PLAN OF ALUM. PICKET RAIL AT RETAINING WALL

FOR APPROVAL

a DATE: 11-94 BY: D.H. CHKD:		b DATE: BY: CHKD:		FINISH MEDIUM BRONZE ANODIZE		FIELD BOLTS ON 01- A-BOLTS ON 21-		TF THOMPSON FABRICATING COMPANY "ENGINEERING FROM THE OUTSIDE IN"		S.O. 93512 SHEET No. _____ OF _____	
c DATE: BY: CHKD:		d DATE: BY: CHKD:		PAINT AL. IN CONTACT WITH CONC. 1/2" ELECTROLYTIC		REF. DWGS. 219		STRUCTURE WATER T&T, FAC. LOCATION HARBORMAN, TO.		DWG. No. _____	
						DRAWN BY D. HOWELL CHECKED BY _____		CUSTOMER JUDY CONST. ENGINEER ELROD-DUNSON, INC. DETAIL OF AL. PICKET RAIL		E55-2

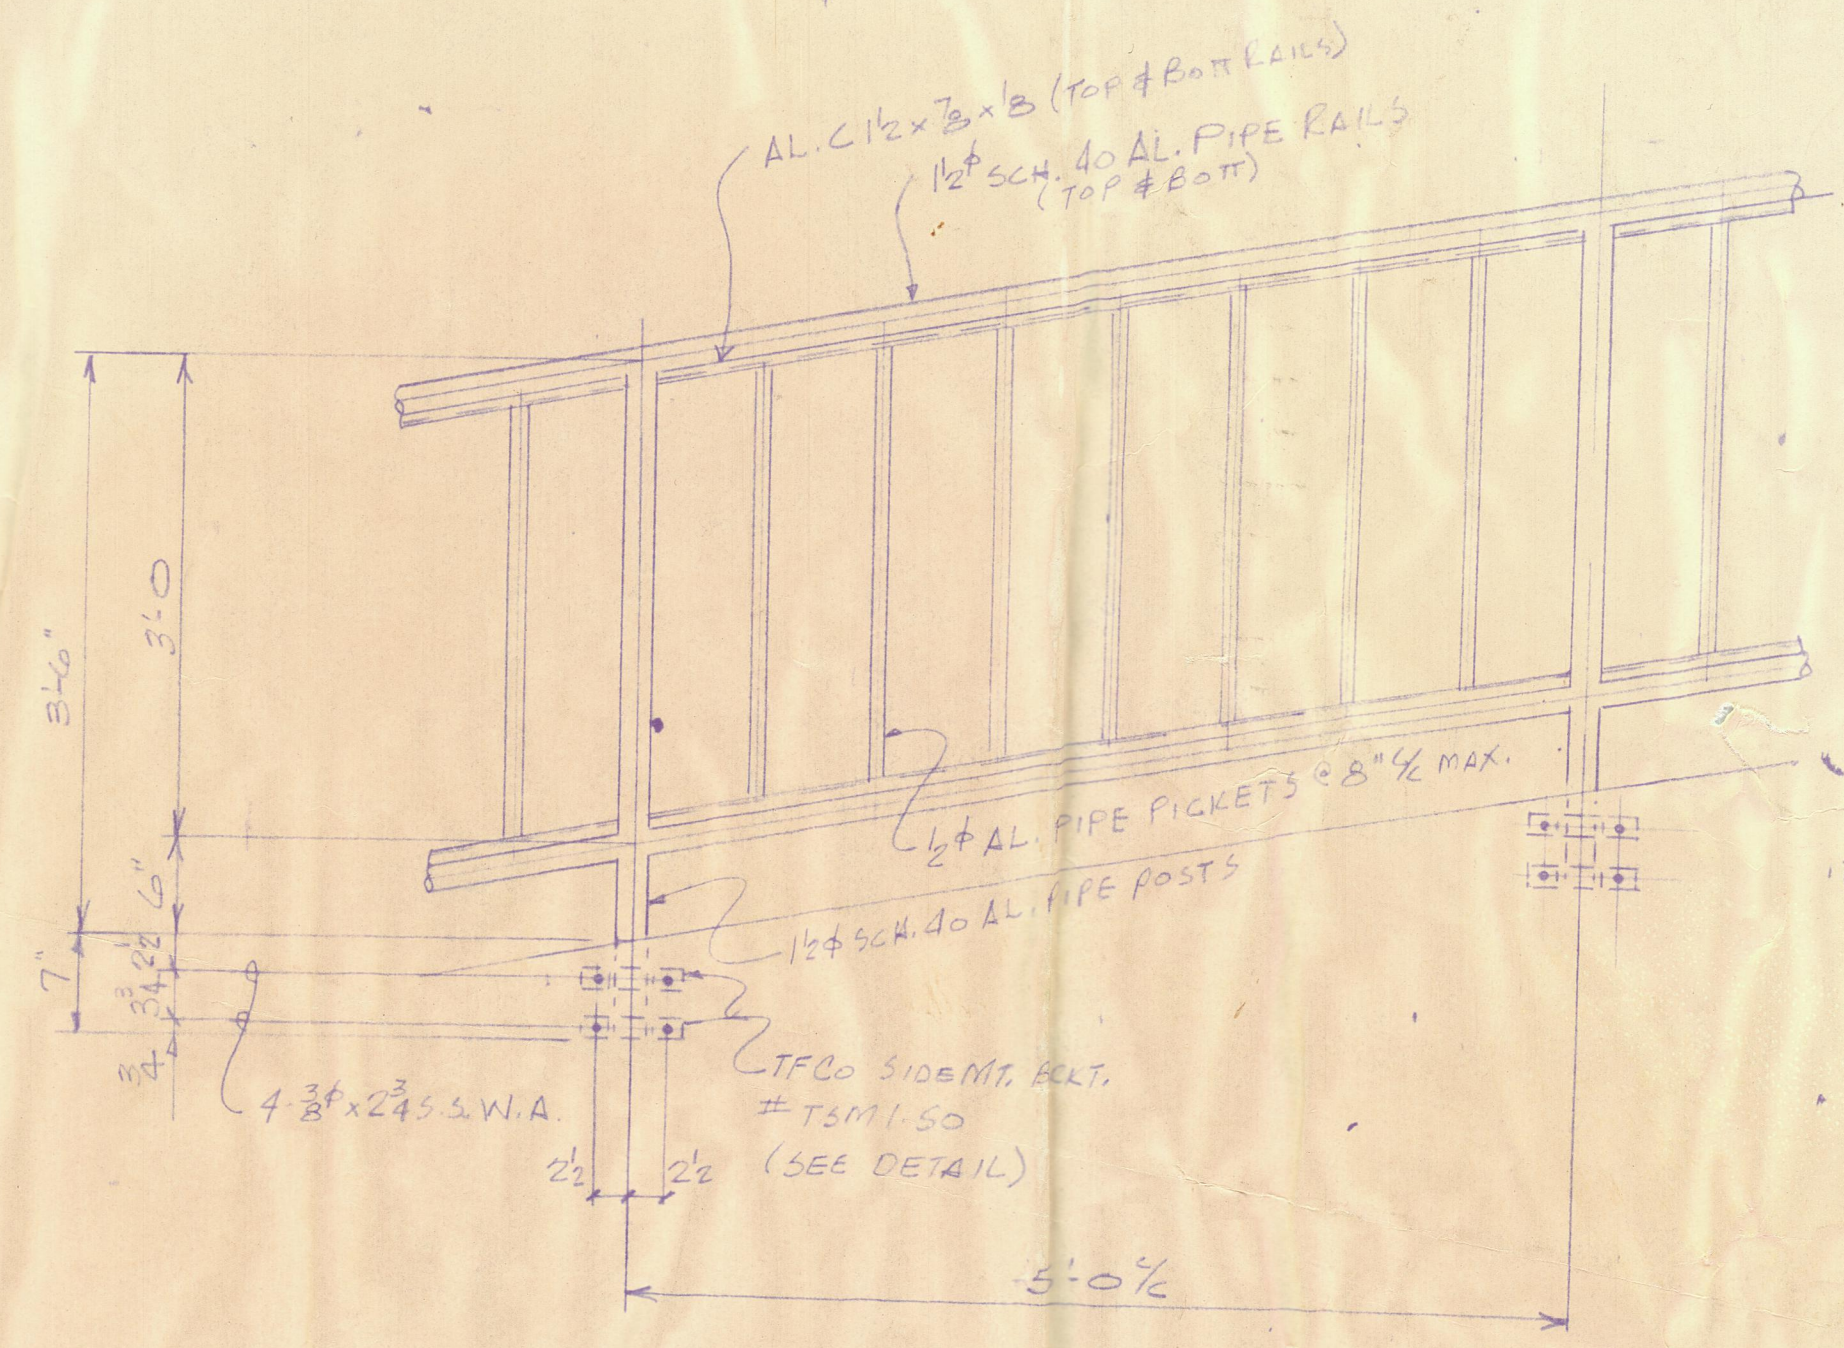
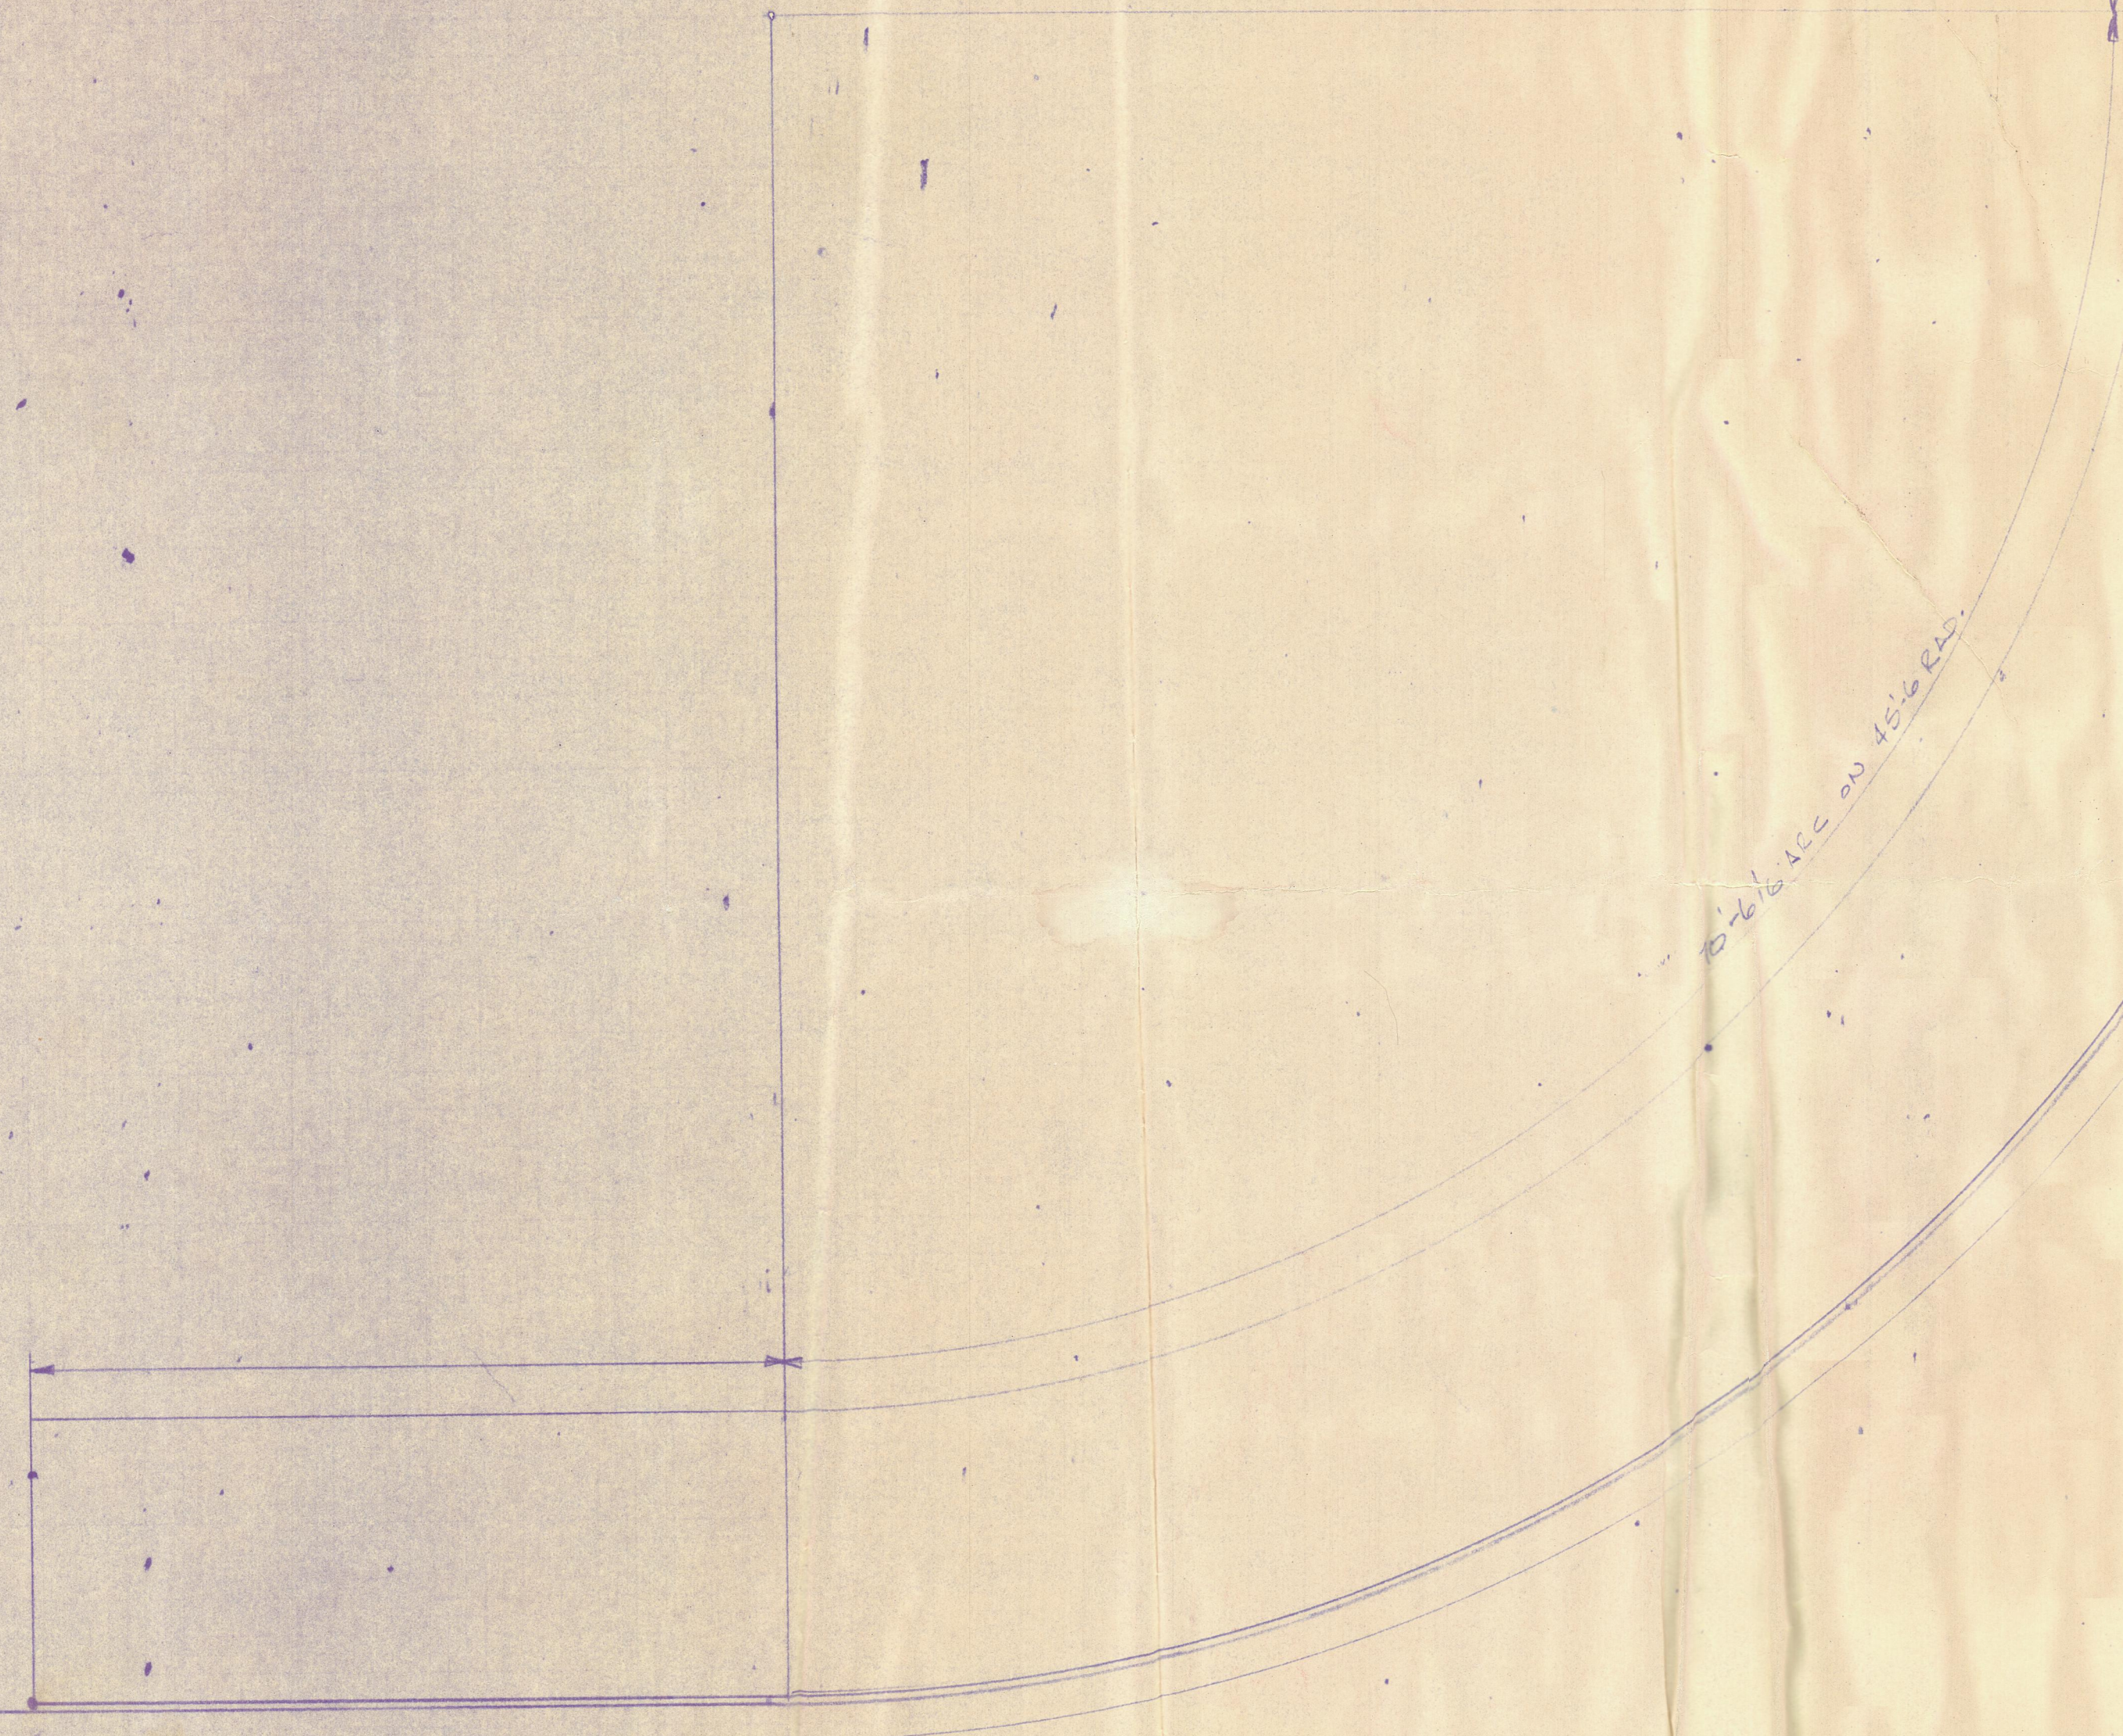
CONTR. NOTE
PLEASE PROVIDE:
1. ELEVATIONS
2. HORIZONTAL DIMS.
3. VERIFY RADII

HOLD HANDRAIL FOR FIELD
DIMENSIONS.
